DOE/NE-ID-11150
Revision 1
November 2004

**Group 2 Remedial Design/Remedial Action
Work Plan Addendum 2 for the TSF-09/18
V-Tanks and Contents Removal, Phase 1
Contents Treatment, and Site Remediation
at Test Area North, Waste Area Group 1,
Operable Unit 1-10**

REVISION RECORD

Figure F-1. Conceptual design for Tank V-9 macroencapsulation.

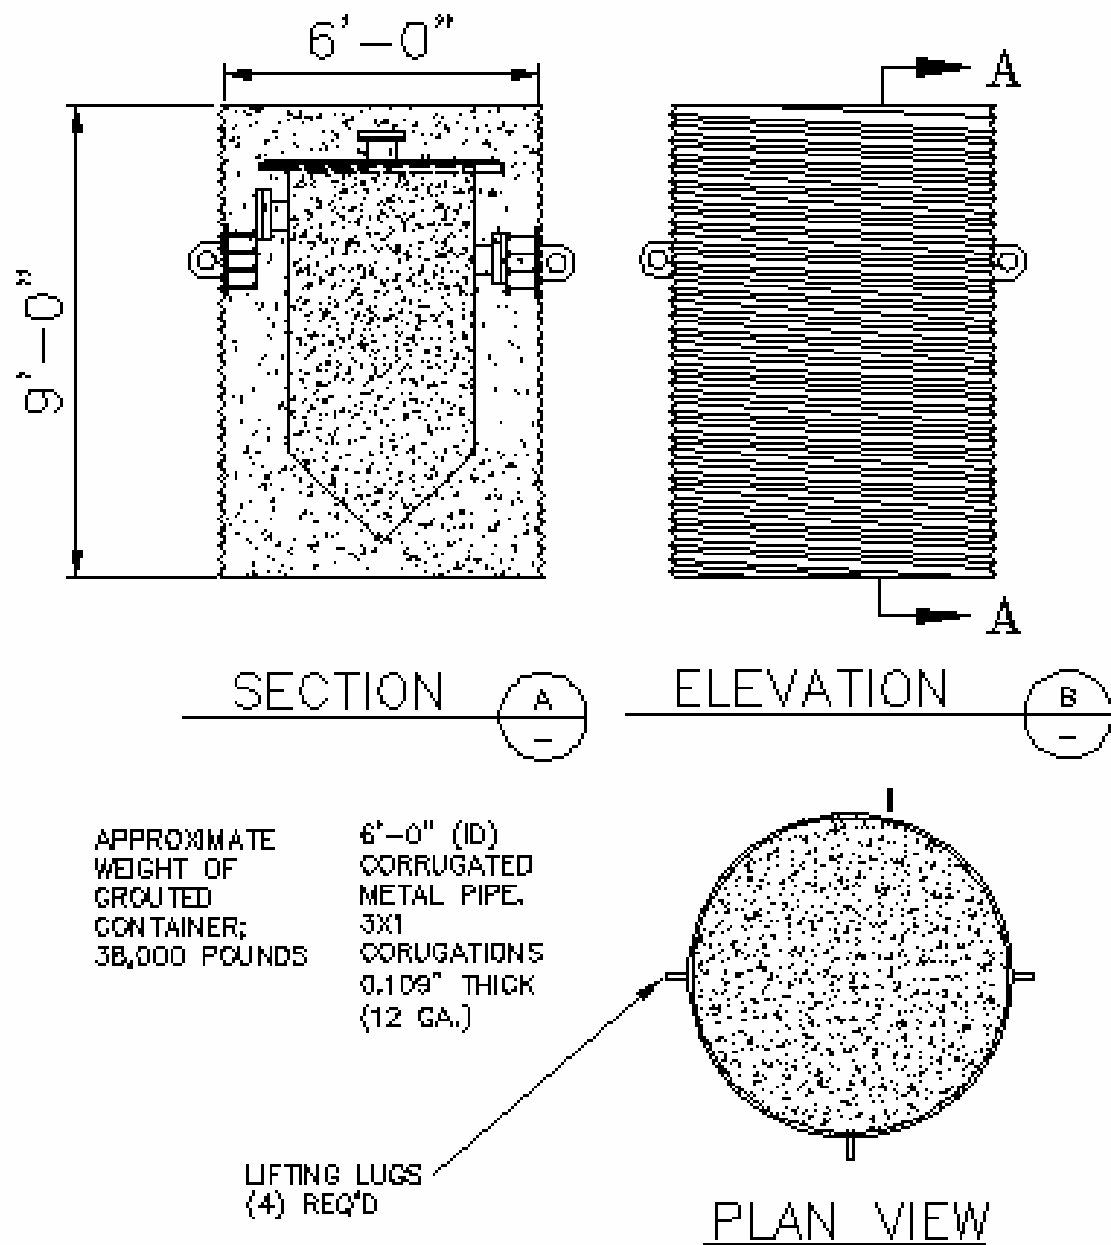
24	Appendix G	G-3	Page G-3, Appendix G. Macroencapsulation of V-9 has not been described in detail, and Figure G-1 provides only minimal details as to the specifics of encapsulation of V-9 if necessary (due to incomplete removal of the contents). This could probably be better treated as a contingent remedy and described in detail, with the appropriate figures, when the need arises.	Comment noted: Macroencapsulation is a contingent measure. If macroencapsulation is needed, we will develop work control documents to address the revised approach. Those documents will be available to the Agencies upon request.
25	DWG C-2		Drawing Sheet C-2, Site Plan. For the sake of clarity and relative positioning of target units, please add labels and arrows to the two other sites, namely "Sites 1 and 2", similar to what was provided on Sheet C-6. Also, please label the dotted line just east of the future soil stockpile area.	Incorporated. Labels were added for Sites 1 and 2 and the dotted line.
